TRANSMITTAL COVER SHEET

DATE: 21 June, 2024
TO: ALL PLAN HOLDERS OF RECORD
FROM: HUNTER SWATEK, AIA, PROJECT MANAGER
PROJECT: RAINBOW CITY RECREATION CENTER
GMC PROJECT NO. ABHM230021
RE: ADDENDUM NO. 3 AND
ACKNOWLEDGEMENT OF RECEIPT OF ADDENDUM NO. 3

ADDENDUM NUMBER 03

**PROJECT: RAINBOW CITY RECREATION CENTER
GM&C PROJECT NO. ABHM230021**

ALL REINFORCING STEEL SHALL BE CENTERED IN FLOOR & WALLS GENERALLY, BUT OTHER MISC. BARS SHALL HAVE MIN 2" COVER ON POOL FINISH SIDE & 3" COVER ON EARTH SIDE.

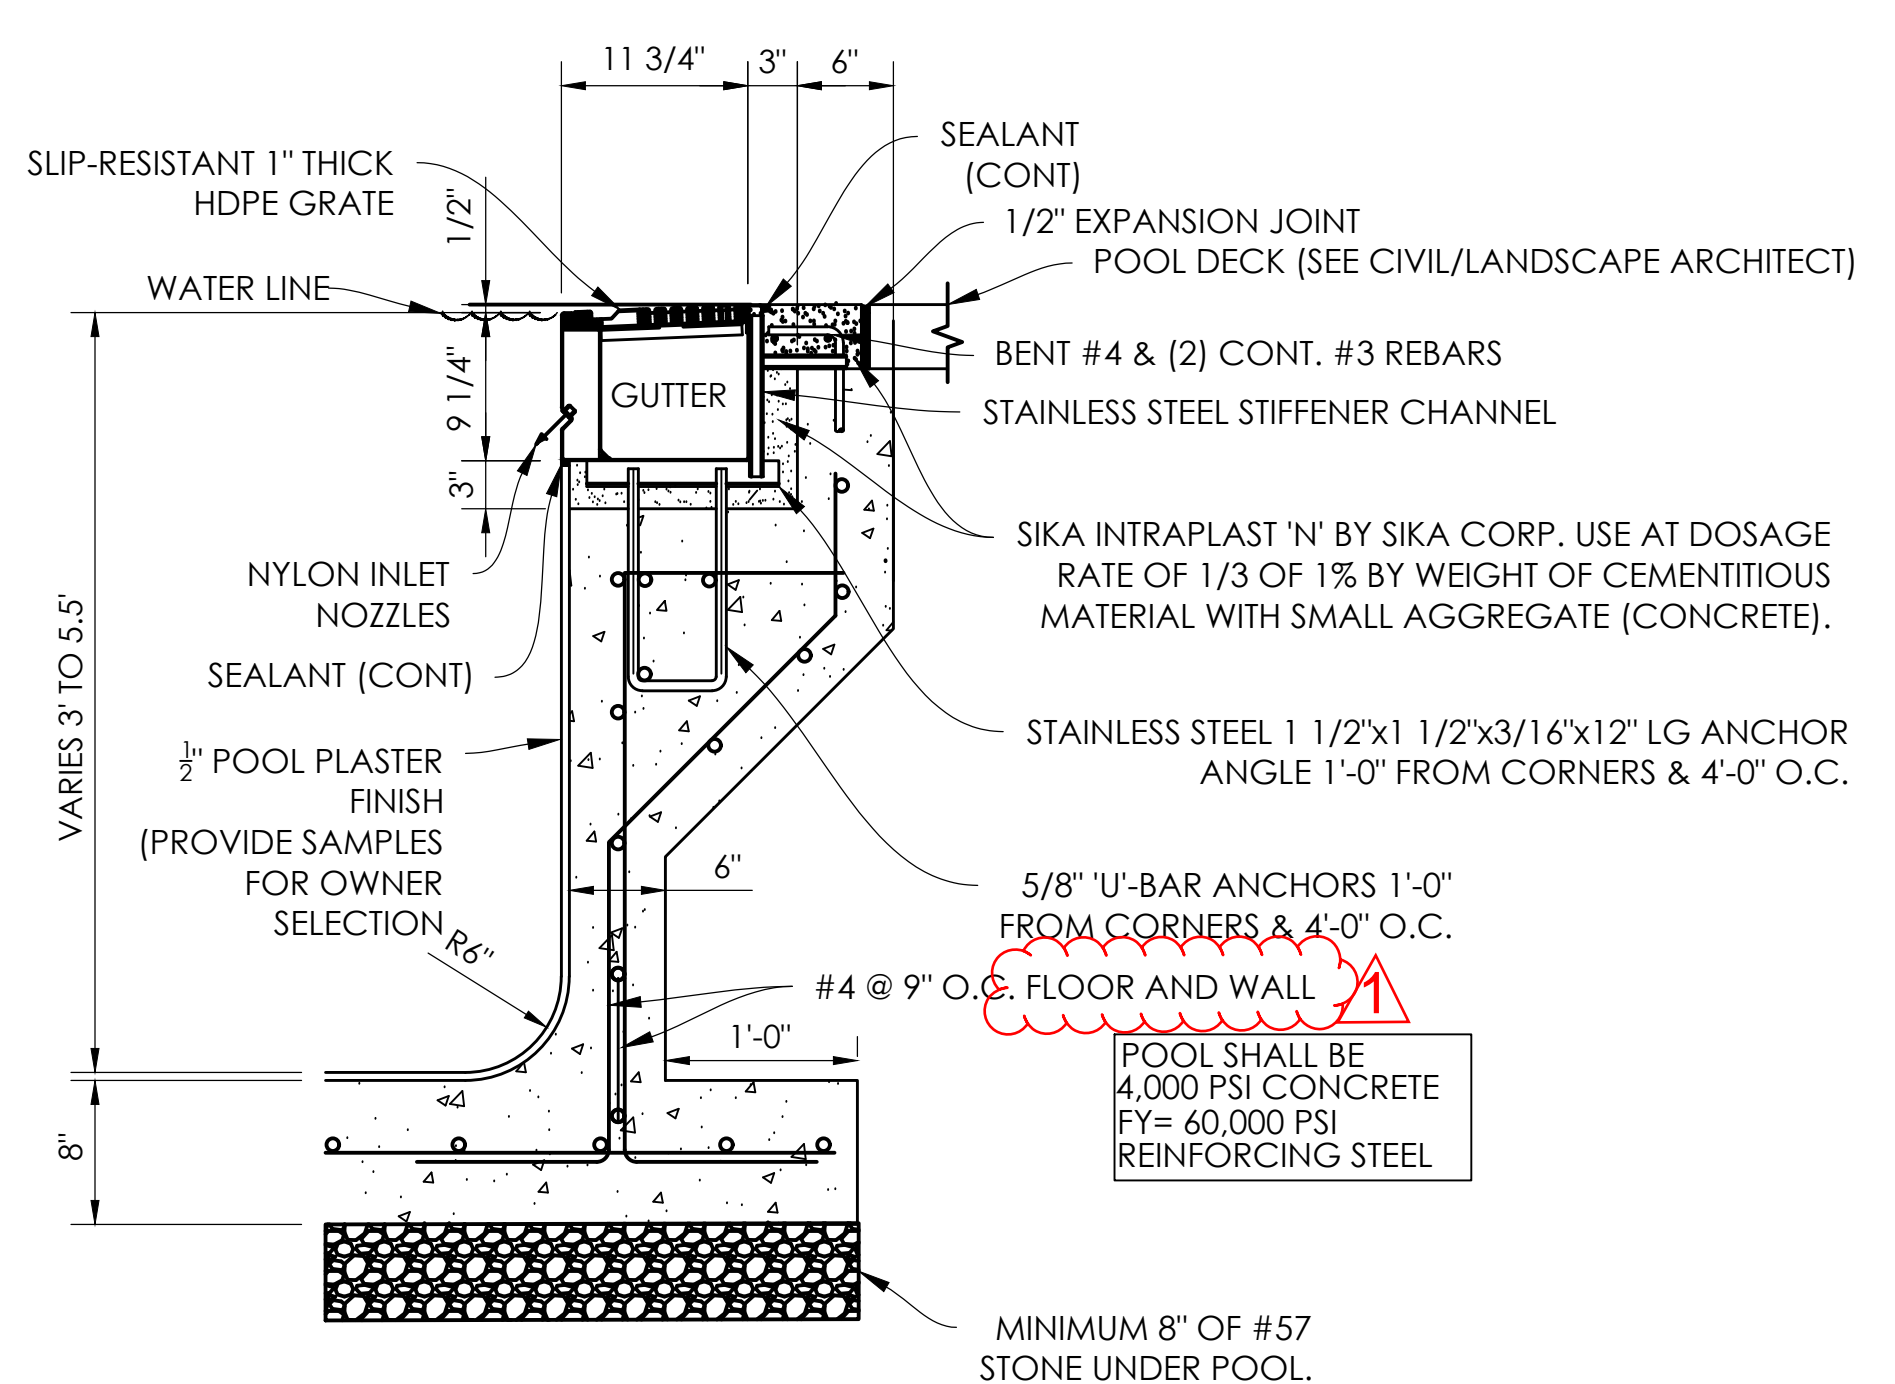
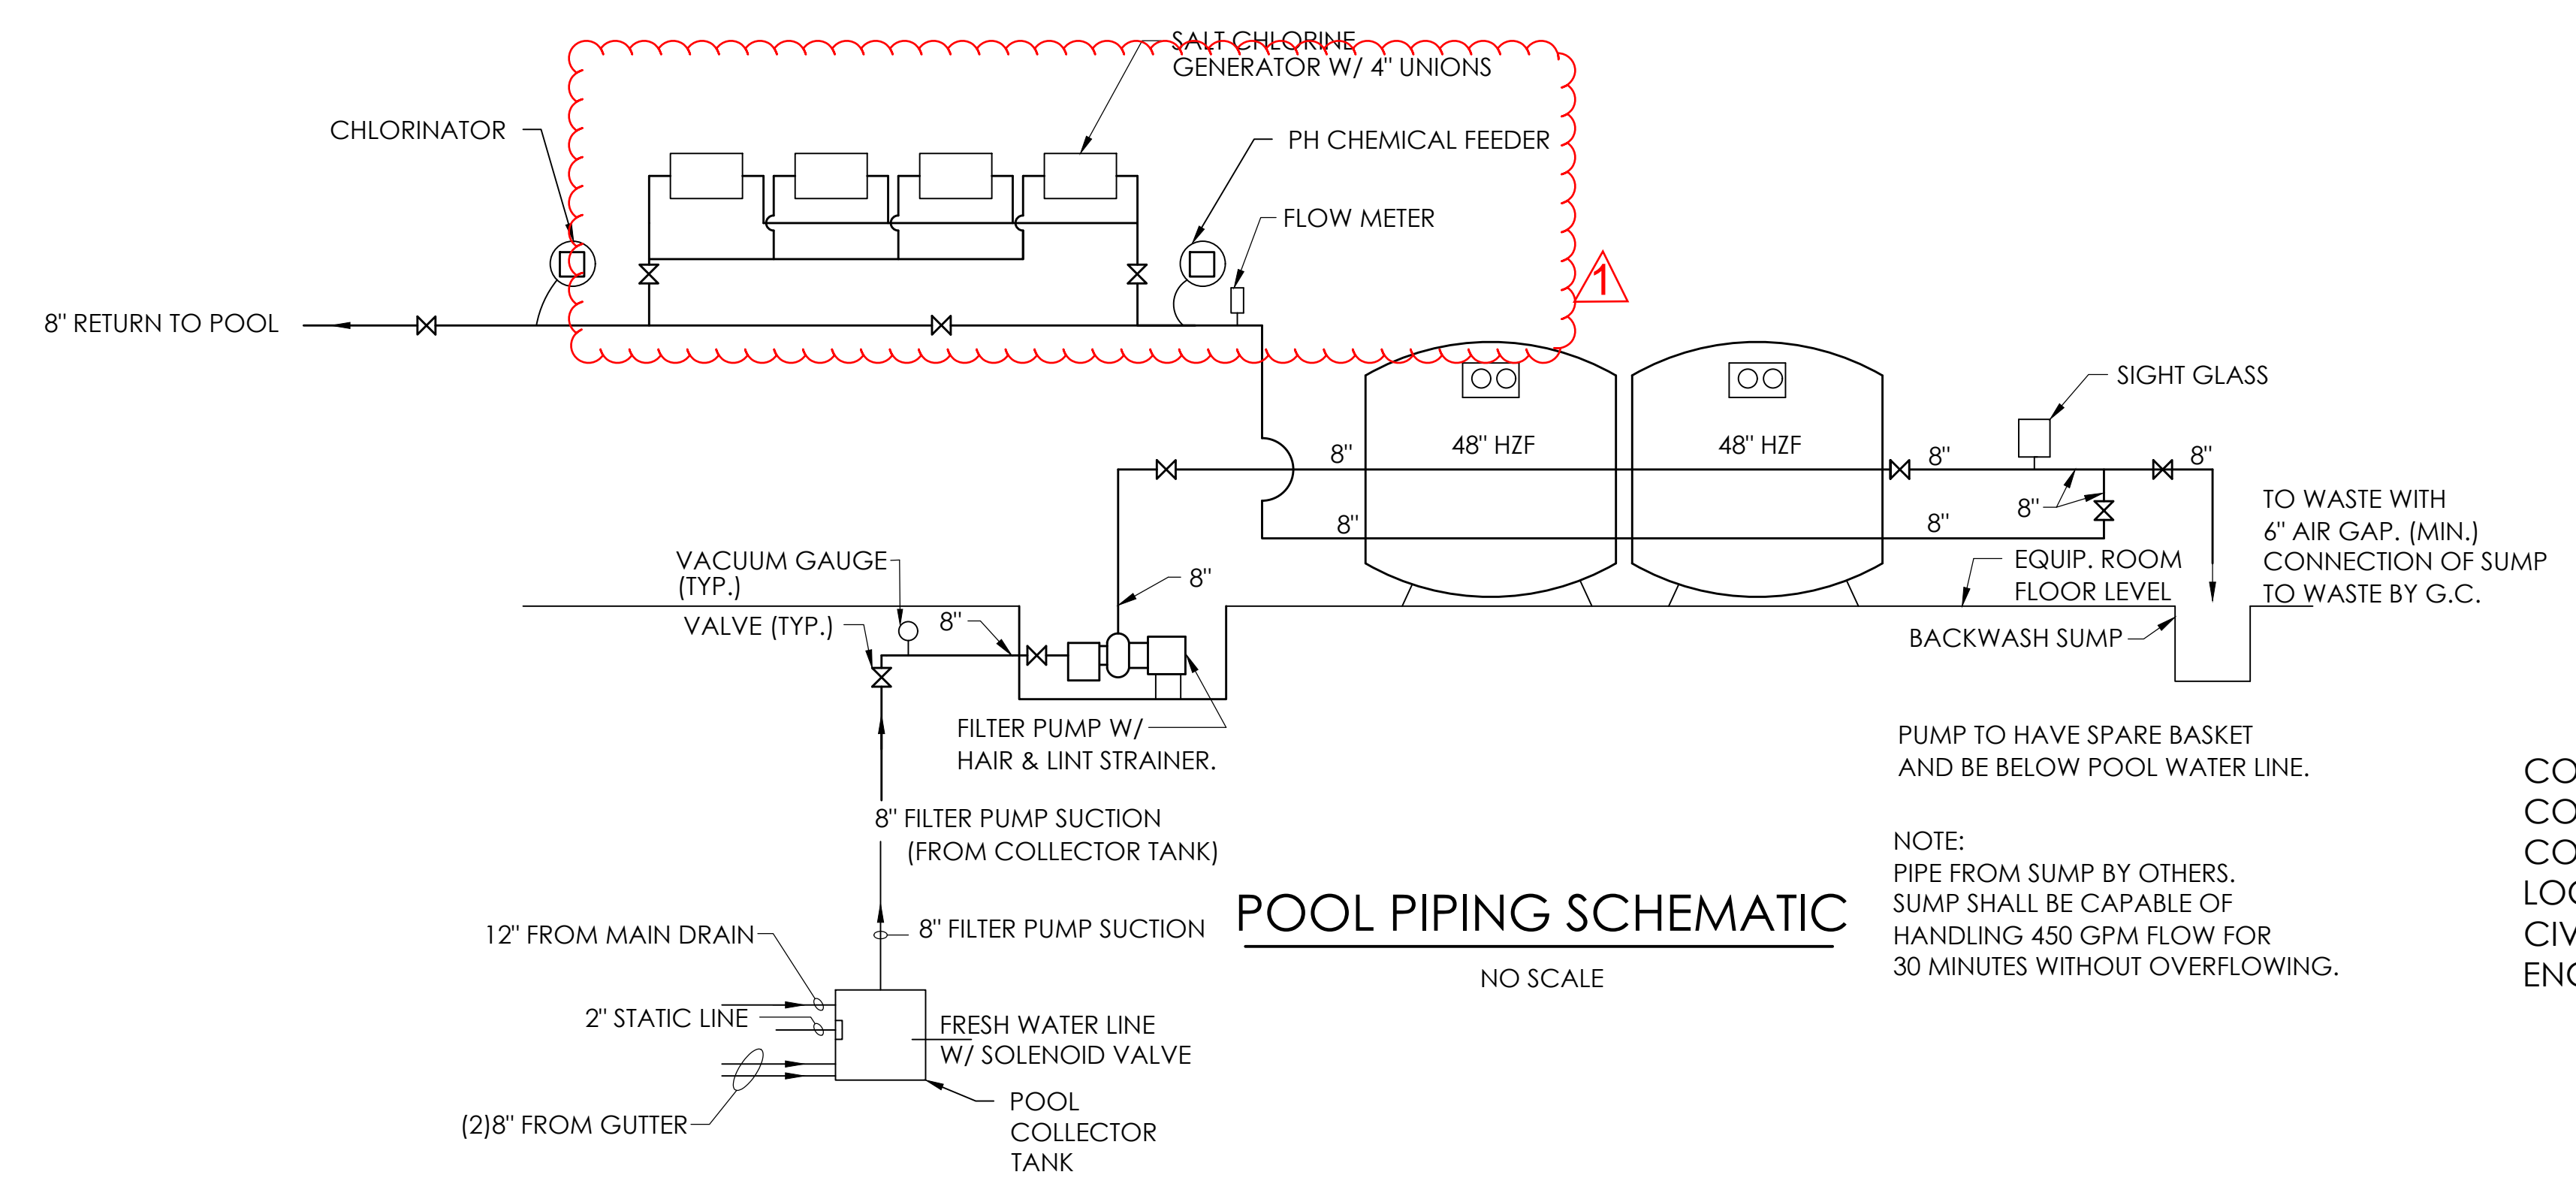
- b. REVISED Discharge pump tag
 - c. ADDED Pool filter sump along with 8" storm piping connecting to the 6" FS
- FF. SP1.01, SP1.02, SP2.01, SP2.02, SP2.03, SP2.04 – Pool Addendum 03**
- a. Pool main drains have been updated from (3) 24"x24" Drains to (1) 18"x36" Drain.
 - b. Note added on Pool reinforcement.
 - c. Note added regarding gutter warranty requirement.
 - d. Note added regarding alternate vendors requirement.
 - e. Specifications sheets have been provided for pool.

The pool designer called out the rebar spacing for the wall but not the floor. See SP1.01, wall detail. Is the floor rebar also 9" OC or different? It appears to be different, please advise	3	See updated Pool Drawings
	Specification Section 12 6613, Part 2.02 A requires seating to be manually operated. However, Part 2.02, B 6 requires electrically operated. Please clarify.	3	All telescoping bleachers to be manually operated.
	Porter is specified for the Gymnasium Equipment. However, they are not specified for Section 116653-Gymnasium Dividers. Do they need to submit a Substitution Request to be allowed to bid the Gymnasium Dividers? Usually Gymnasium Equipment and Dividers are supplied by the same vendor.	3	Porter is approved for both gymnasium equipment and dividers.
	The specifications are calling for the metals to be a 3-coat finish. The supplier just reached out and said that we could not get a quote on this due to the size, we would not meet the minimum order quantity for special finishes. Please advise if we should quote the standard 2-coat finish.	3	The metal panels in 07 4291 can be finished in a 2-coat Fluoropolymer (Kynar) finish
